#### Objective: Comply with Village of Lombard Parking Codes

- At the July 17<sup>th</sup>, 2023, Plan Commission meeting, the Plan Commission directed CWP and staff to provide an amended site plan for review that would comply with Village Parking Ordinances and eliminate any requested parking variances.
- CWP and Village staff then collaborated to find additional areas for parking within the site.
- The new plan achieves 216 parking spaces, with a parking ratio of 1.5 spaces per unit. This is fully compliant with the Village Ordinances.

## Amended Site Plan – 216 spaces

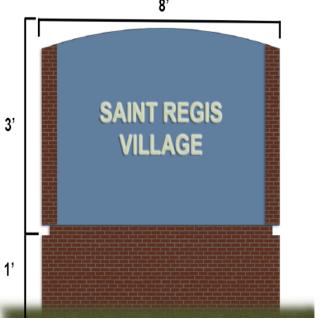
Restriping the existing parking area to have spaces with the width required by Village Code increased parking count from 157 to 176 spaces.

# **NW** Corner pictures

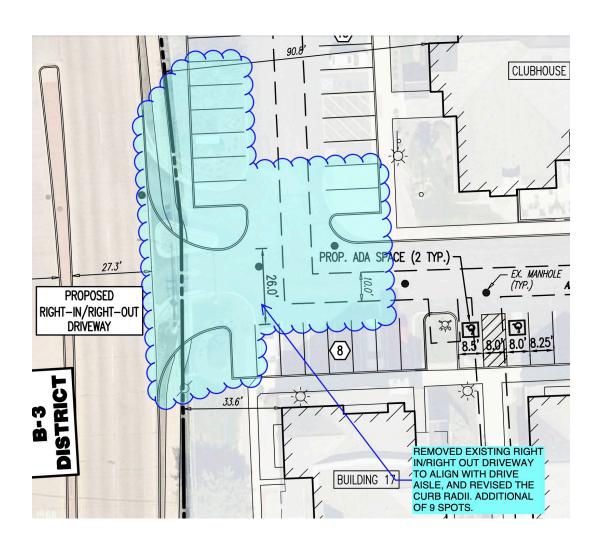
#### NW Corner – 12 additional parking spaces

- The following modifications were reviewed by and are supported by the Department of Public Works.
  - Extension of parking at the NW corner, achieves 11 additional spaces.
  - Curb Modification results in the 12<sup>th</sup> additional spot.
  - Existing trash enclosure is relocated.

# S. Highland Entrance pictures

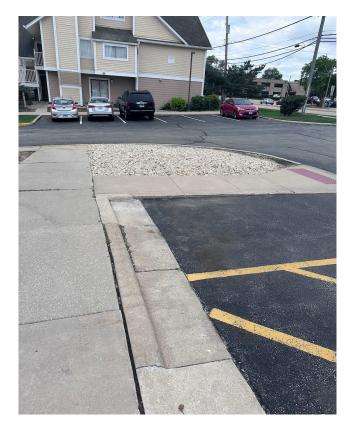
## S. Highland Entrance – 9 additional parking spaces

- S. Highland Entrance is reconfigured in accordance with Department of Public Works recommendations. creating 9 additional parking spaces.
  - Existing monument sign is removed.
  - Pedestrian safety is improved, with a sidewalk extension, stop sign and right-turn only.

#### Clubhouse Parking Island - 4 additional parking spaces

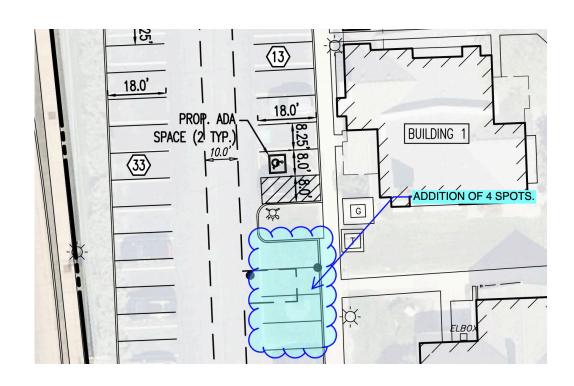
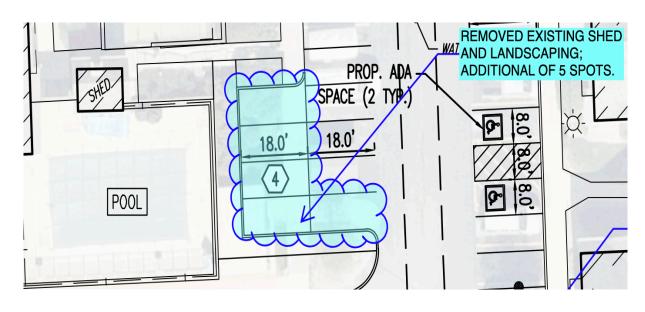
- The following modifications were reviewed by and are supported by the Department of Public Works.
  - Parking Island is removed.
  - Hydrant is maintained.
  - ADA spaces for the Property remain compliant, with one ADA space relocated, from here, to the North.

# Pool Area / Shed pictures

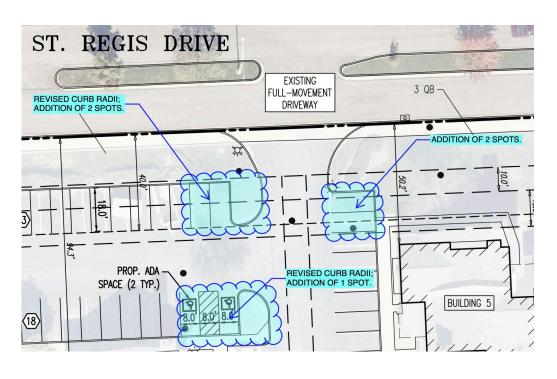
#### Pool Area- 5 additional parking spaces

- The following modifications were reviewed by and are supported by the Department of Public Works.
  - Pool Shed is removed, creating space for 1 additional standard space and 4 tandem spaces.
  - In accordance with staff recommendation, the tandem stalls will be assigned to particular units for exclusive use.
  - Landscape removal is offset elsewhere on site.

## St. Regis Drive Entrance pictures

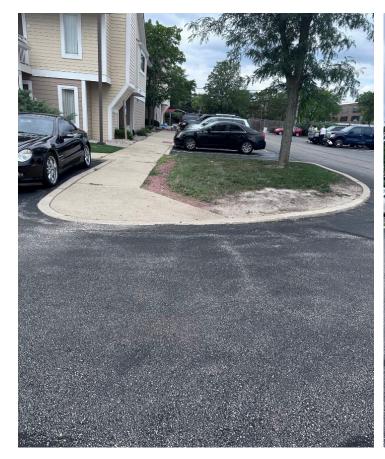
#### St. Regis Drive Entrance - 5 additional parking spaces

- The following modifications were reviewed by and are supported by the Department of Public Works.
  - Two additional parking spaces are created on each side of the St. Regis Entrance by relocating landscaping areas.
  - The 5<sup>th</sup> space is created by narrowing an interior landscaped island. This includes the relocated ADA parking space, mentioned above.
  - New Landscape Island Trees will be planted, per Village Code Provisions.

### SE Corner - 5 additional parking spaces

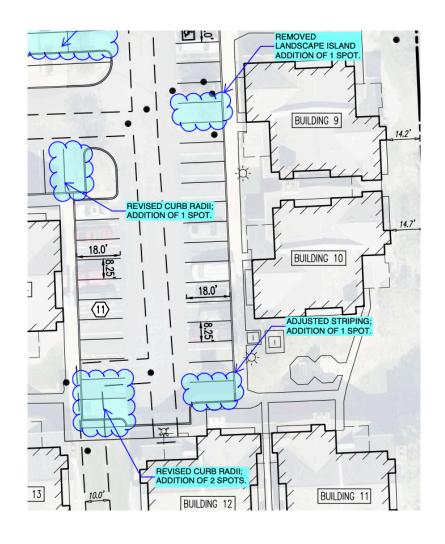
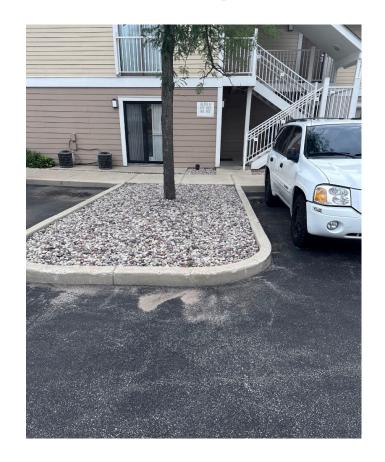
- The following modifications were reviewed by and are supported by the Department of Public Works.
  - Revising curb radii create 3 additional parking spaces.
  - The 4<sup>th</sup> parking space is created through adjusted striping.
  - The 5<sup>th</sup> parking space is created by removing a landscape island.

#### Maintaining 35% Open Space with Removal of Sports Court

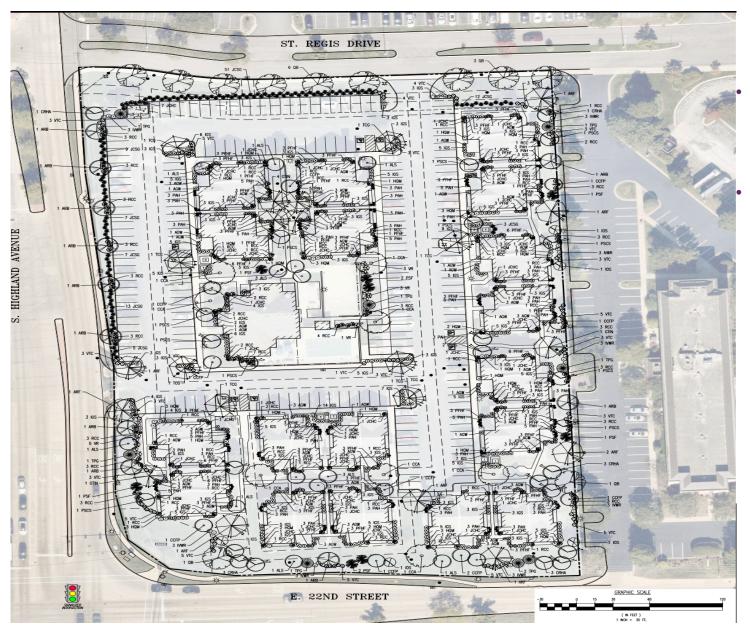
- With the review and approval of the Public Works Department, all landscaped areas that qualified as Open Space and were removed to accommodate additional parking will be offset by expanding the Open Space where the Sports Court is currently located.
- Removing the Sports Court and replacing it with lawn will create 1,719 SF of Open Space.

### Sign Monument – Existing

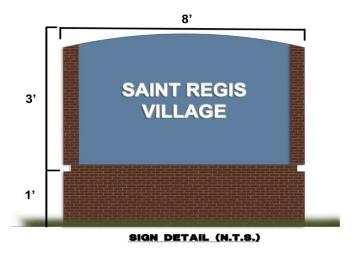
Existing sign monument at the property is located on S.
Highland Ave, but will be removed from its existing location.
